Guru Nanak Foundation of America: Preliminary Plan 120120160

Staff Report Date: 11-27-13

**Guru Nanak Foundation of America
Preliminary Plan 120120160**

Staff Recommendation: *Approval with Conditions*

PRELIMINARY PLAN
 SCALE: 1" = 50'

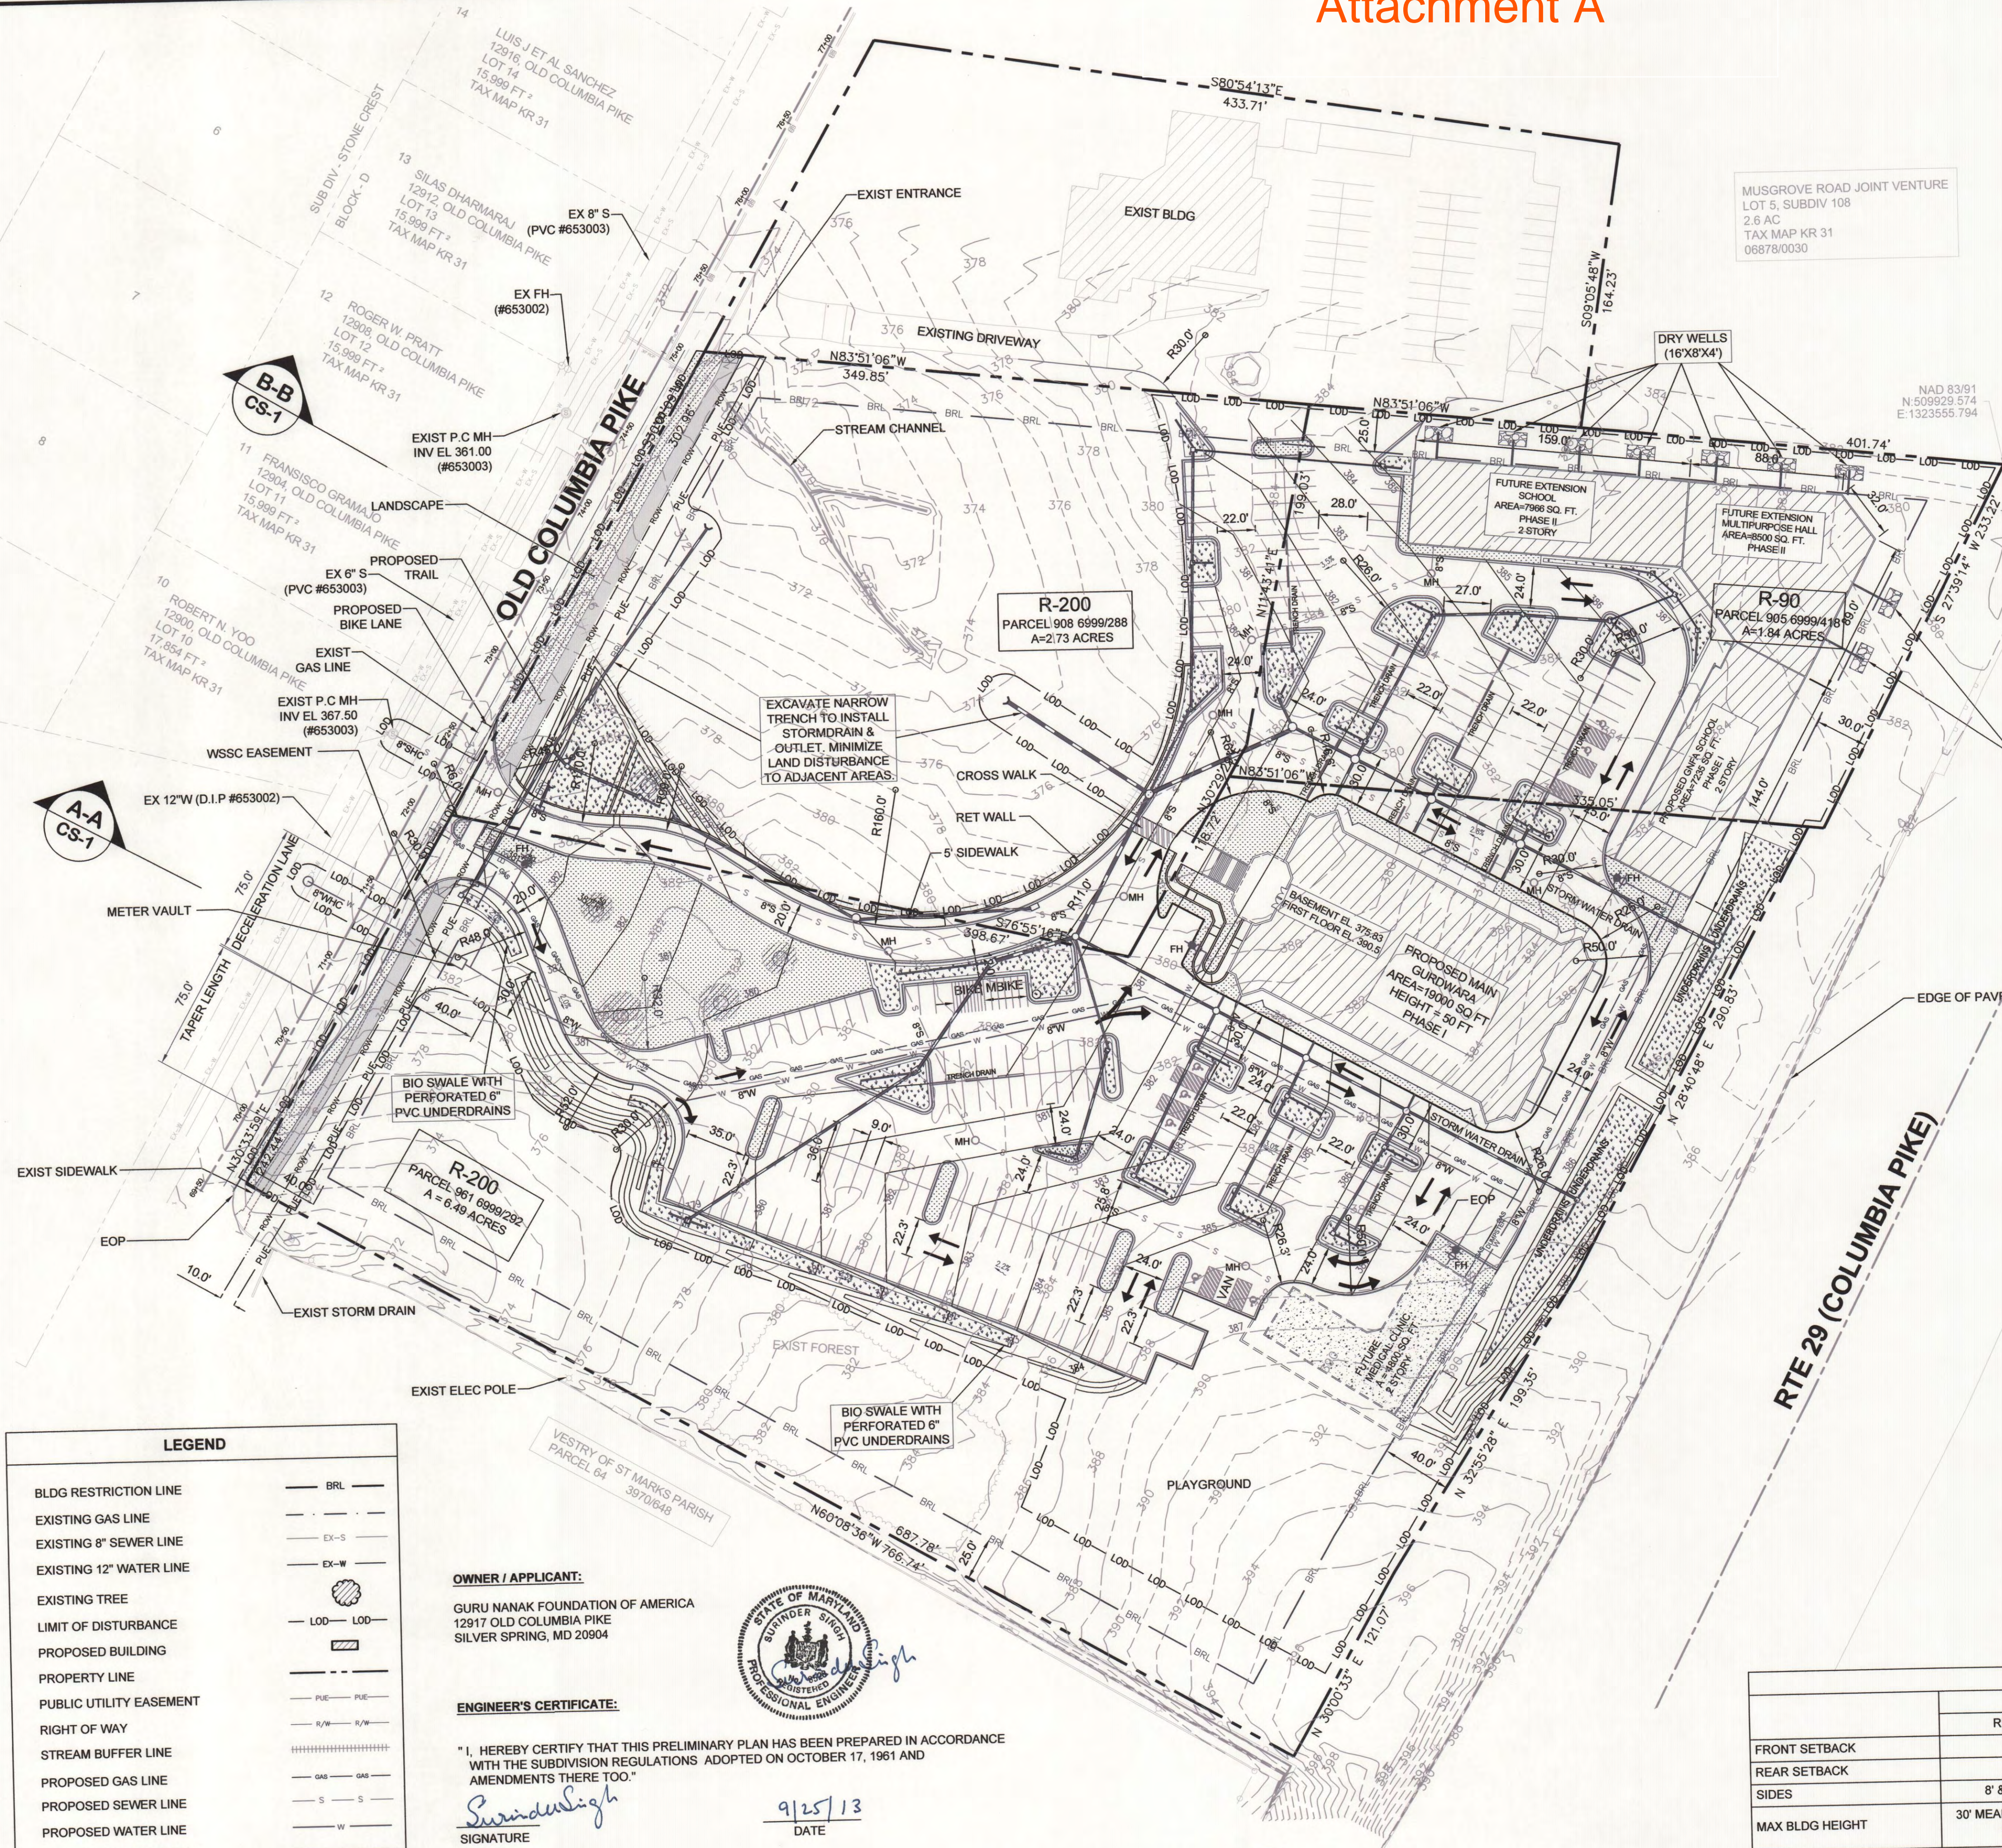
9. The record plat must show necessary easements.
10. The Certified Preliminary Plan must reflect the following changes:
 - a. Remove reference to a “future medical clinic” and instead label this as a future use.

We have completed our review of the March 12, 2013 revised preliminary plan. An earlier version of this plan was reviewed by the Development Review Committee at its meeting on May 21, 2012. We recommend approval of the plan subject to the following comments:

1. The revised plans should be signed and sealed prior to the Planning Board hearing.
2. Necessary dedication along Old Columbia Pike and US29 in accordance with the master plan.
3. Per the meeting on February 28, 2013, grading within the public right-of-way shall comply with our Context Sensitive Road Design (CSRD) Standards. Any deviations from these standards shall be justified through a design exception. Design exceptions shall document the design constraints prompting the change & clarify the benefit to the public for the modification. Additional information on design exceptions:

4. Grant necessary slope and drainage easements. Slope easements are to be determined by study or set at the building restriction line.
5. Record plat to reflect denial of access along US 29.
6. Submit revised storm drain capacity and impact analyses study (of the downstream County-maintained storm drain system on Old Columbia Pike) prior to submission of the record plat. Analyze the capacity of the existing downstream public storm drain system and the impact of the post-development ten (10) year storm runoff on same. Prepare storm drain calculations in accordance with the MCDOT Storm Drain Criteria and errata. If the proposed subdivision drains to an existing closed section street, include spread computations in the impact analysis.

PRELIMINARY FOREST CONSERVATION PLAN
 SCALE: 1" = 50'
 1 PFCP

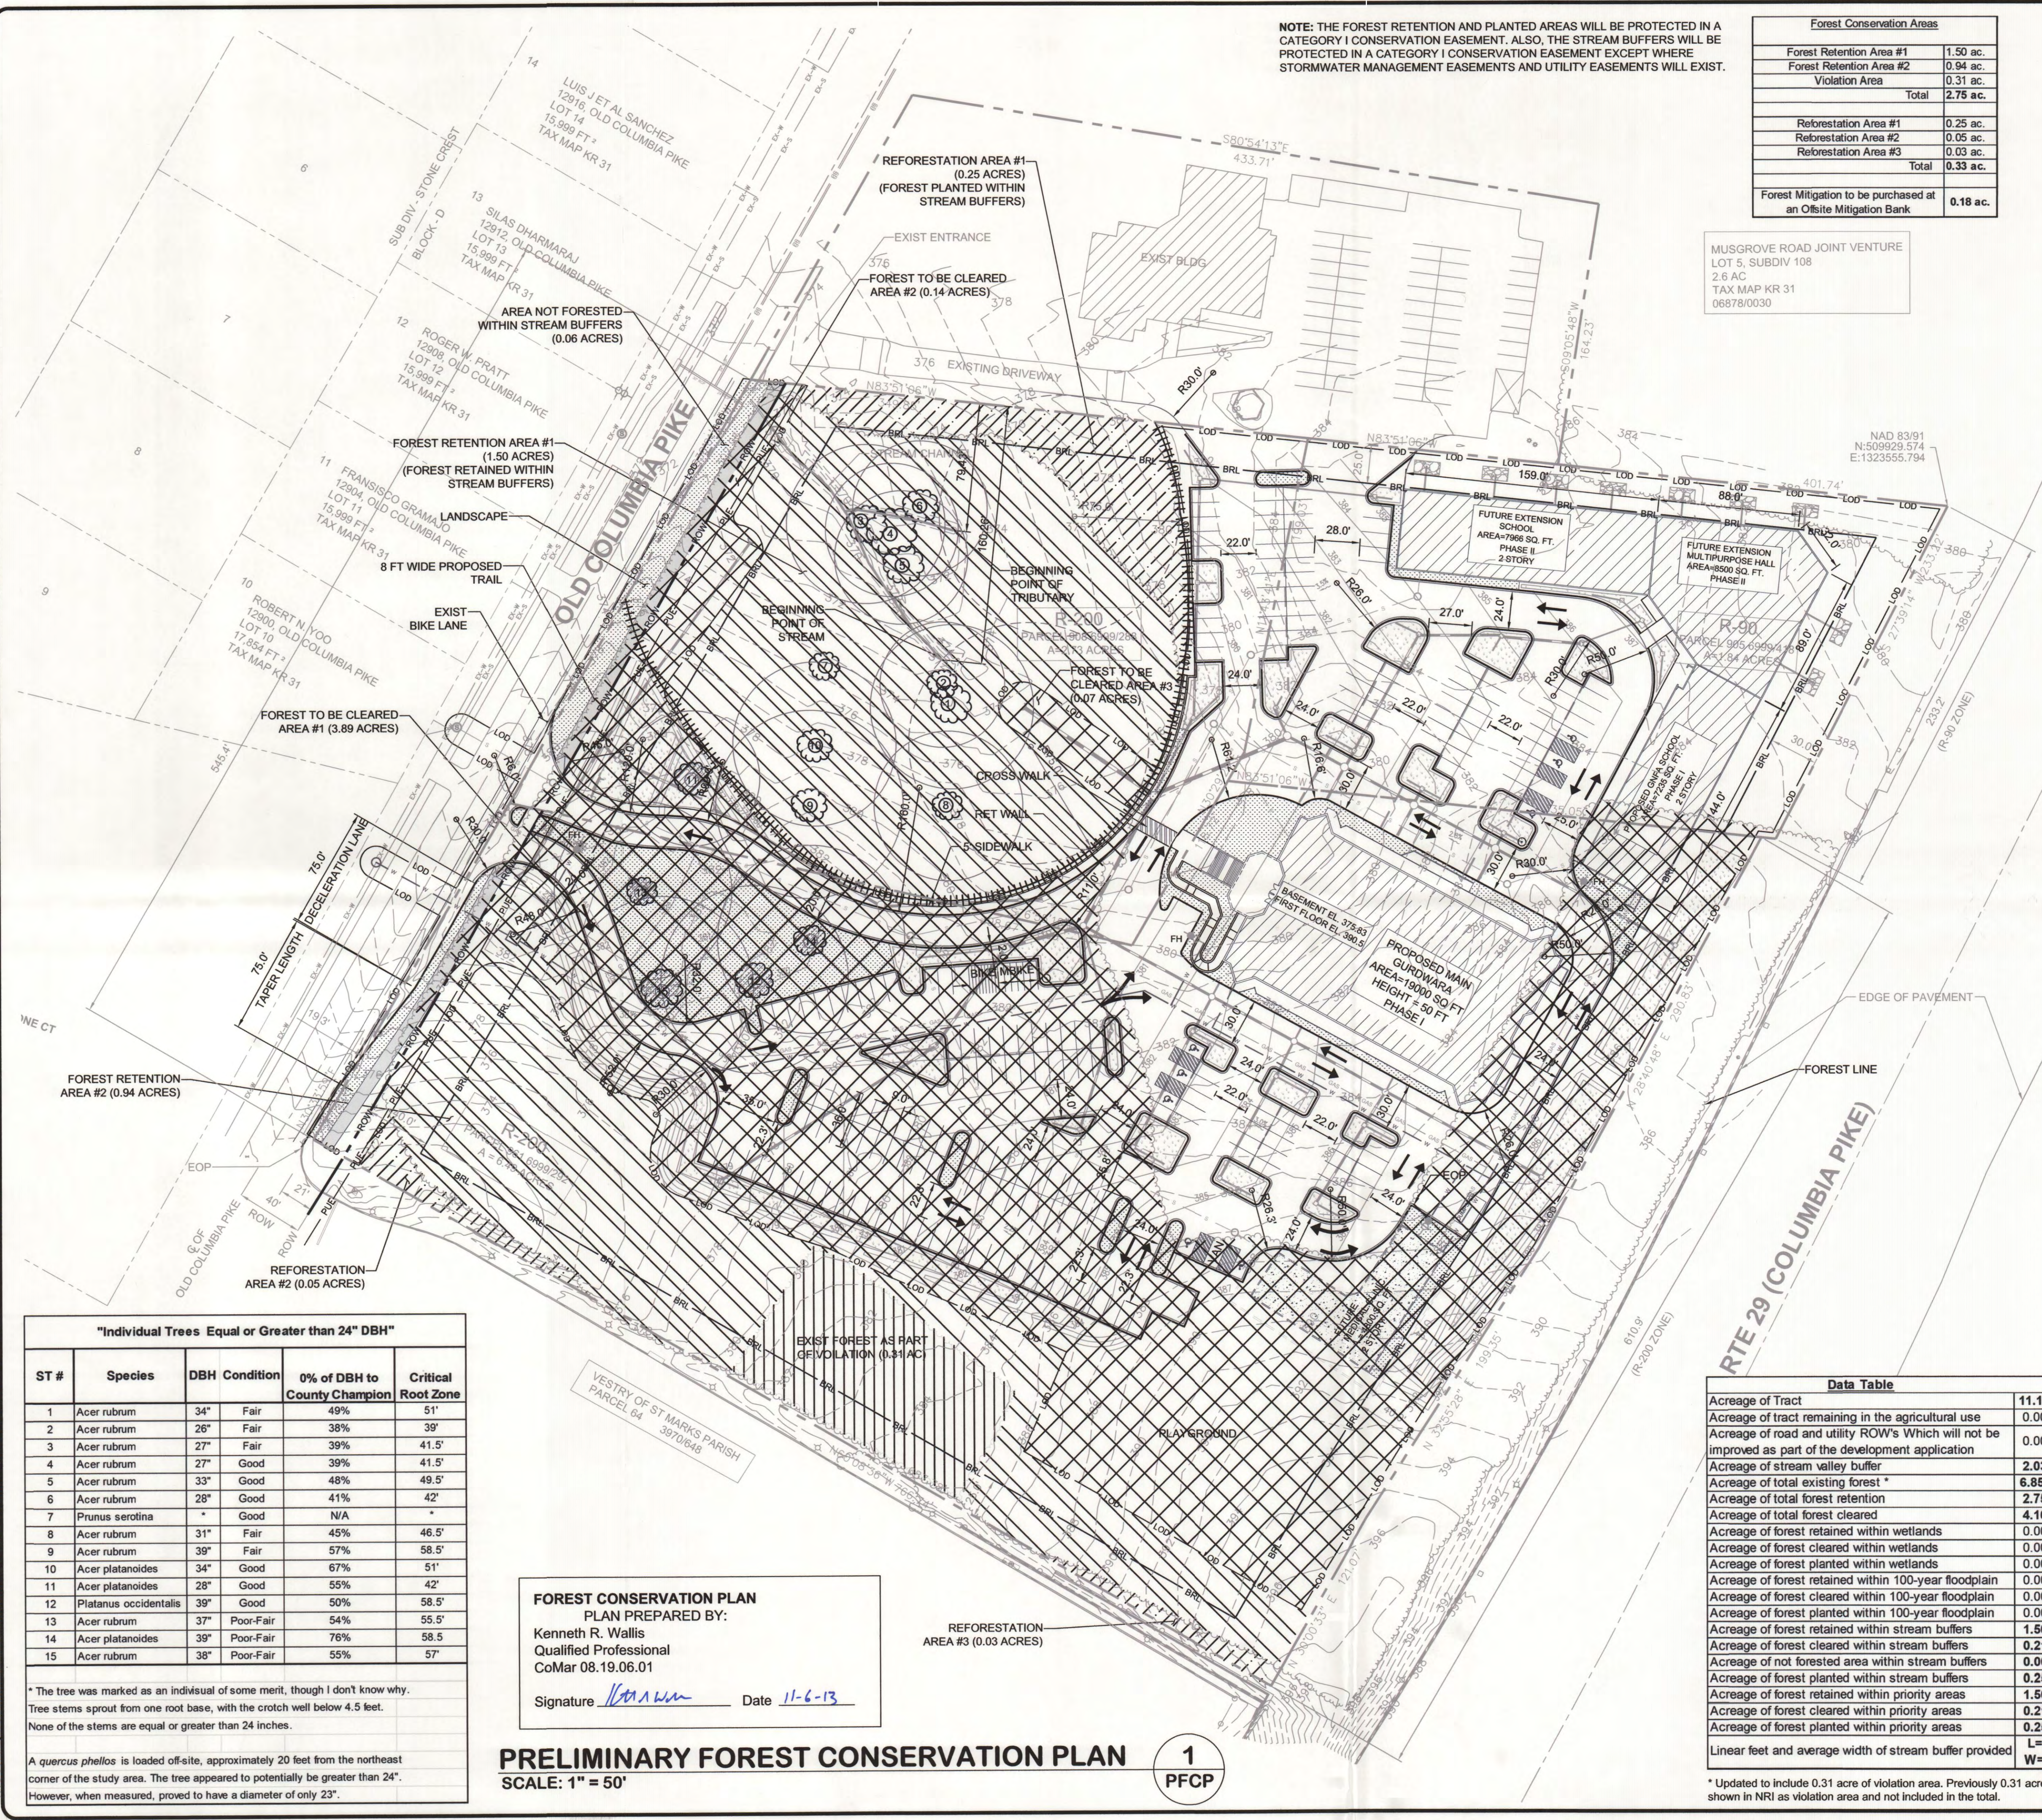
playground, parking, drive aisles and stormwater management features. Approximately 0.21 acres of the total forest clearing will occur within the environmental buffer to allow the construction of two stormwater outfalls. The forest conservation worksheet shows a 0.51 acre forest planting requirement, of which 0.33 acres is proposed to be met onsite with the remaining 0.18 acres to be met offsite. Approximately 0.25 acres of the onsite planting will occur within the environmental buffer located around the stream in the northwest corner of the Property. The 2.75 acres of forest retention and the 0.33 acres of proposed onsite forest planting will be protected in a Category I conservation easement. Staff finds that with the recommended conditions of approval, the Application is in compliance with the Forest Conservation Law.

Variance Request - The Applicant submitted a variance request in a letter dated October 29, 2013, requesting removal of four (4) trees that are 30 inches and greater, DBH, and to impact, but not remove, two (2) trees that are considered high priority for retention under Section 22A-12(b) (3) of the County Forest Conservation Law ("Protected Trees").

Mitigation for Trees Subject to the Variance Provision – This variance request includes four (4) Protected Trees proposed for removal. These four Trees are located within the forest, and their removal is accounted for in the forest conservation worksheet calculations. No additional mitigation is recommended for the loss of these Trees. The two other Protected Trees will receive adequate tree protection measures. No mitigation is recommended for trees impacted but retained.

2. The Applicant must comply with the conditions of approval for the preliminary forest conservation plan No. 120120160, approved with this Application. Conditions of the preliminary forest conservation plan include:

- a. Approval of Final Forest Conservation Plan consistent with the approved Preliminary Forest Conservation Plan prior to any clearing, grading or demolition on the site.
